**Subject:** COMMENT LETTER – 09/02/08 BOARD MEETING: CHINO BASIN  
WATERMASTER DECISION.

Comments on and Requests for Revision to DRAFT Decision Conditionally  
Approving Water Right Application 31369  
Chino Basin, San Bernardino County, California

### Schematic Illustration of Spreading of Plume of Contaminated Groundwater

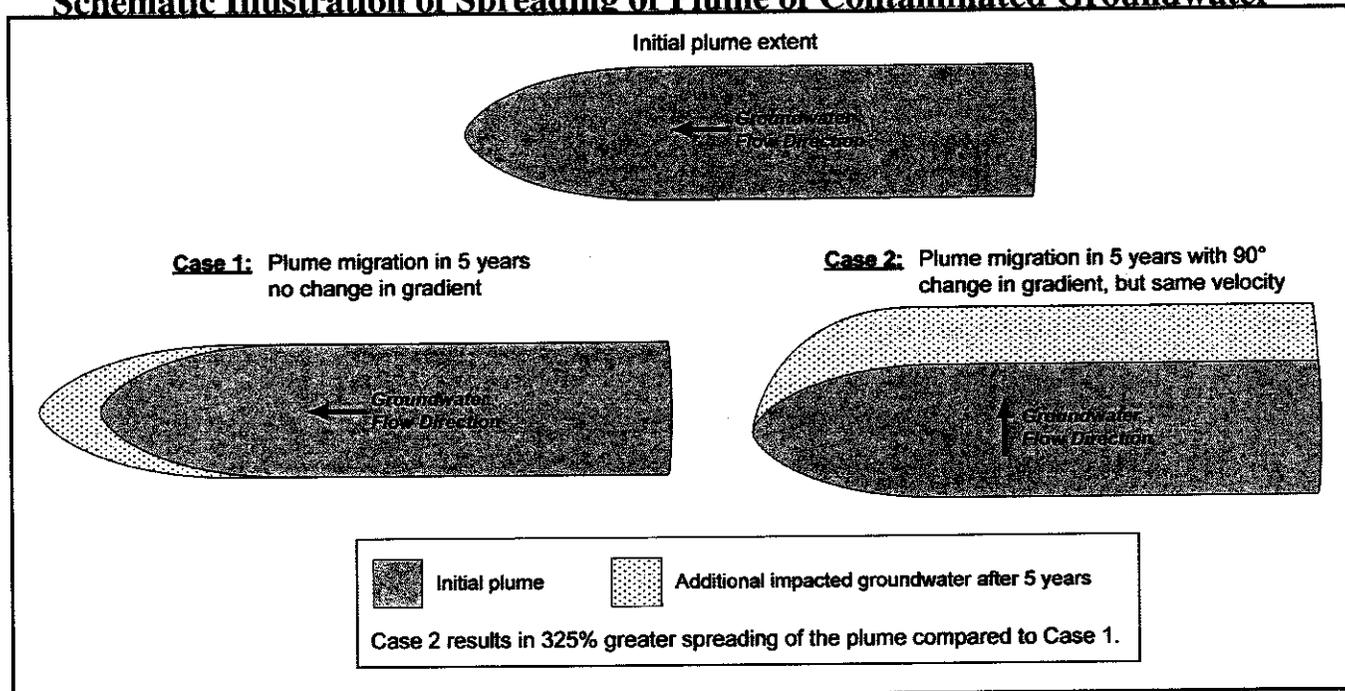
*9. Permittee shall monitor all known contaminated groundwater plumes that may be affected by the diversion of water to recharge groundwater under this permit to determine whether the recharged water will ~~increase~~ **change** the local hydraulic gradient and cause more rapid spread of existing plumes. Permittee shall report annually the results of its monitoring to the Santa Ana Water Board and to the State Water Board. If existing domestic water production wells will be impacted by the plume a minimum of one year earlier than under pre-existing conditions, or if significant quantities of additional groundwater (more than 5,000 acre-feet) will become contaminated within a five-year period due to recharge pursuant to the permit, **additional recharge influencing plume migration shall be curtailed, and** Watermaster shall petition the State Water Board for an alternate location for recharge.*

This language change is requested because a change in flow direction can cause more rapid spread of plumes even if the gradient does not increase. Spreading of a plume of contaminated groundwater is influenced by the width of a plume perpendicular to groundwater flow direction as well as the magnitude of the gradient (velocity). For example, if the flow direction changes by 90 degrees, the volume of an aquifer impacted by spreading of a plume can increase significantly even though the gradient (velocity) remains the same as illustrated on the next page.

Increases in diversion of water to recharge facilities in the Chino Basin will increase groundwater mounding beneath each recharge facility. Although the general regional groundwater flow direction in the Chino Basin may remain essentially unchanged, as shown by regional-scale modeling conducted for the CBWM, the local enhancements in recharge will definitely cause localized changes in hydraulic gradient, which in turn will impact any plume of contaminated groundwater that is sufficiently close to a recharge facility. The statement in the CBWM closing brief submitted to the SWRCB that the "Watermaster presented uncontested and unequivocal evidence that its recharge of storm water under Application 31369 will not cause the plumes of contamination in the Chino Basin to move differently than they are already moving" is simply incorrect.
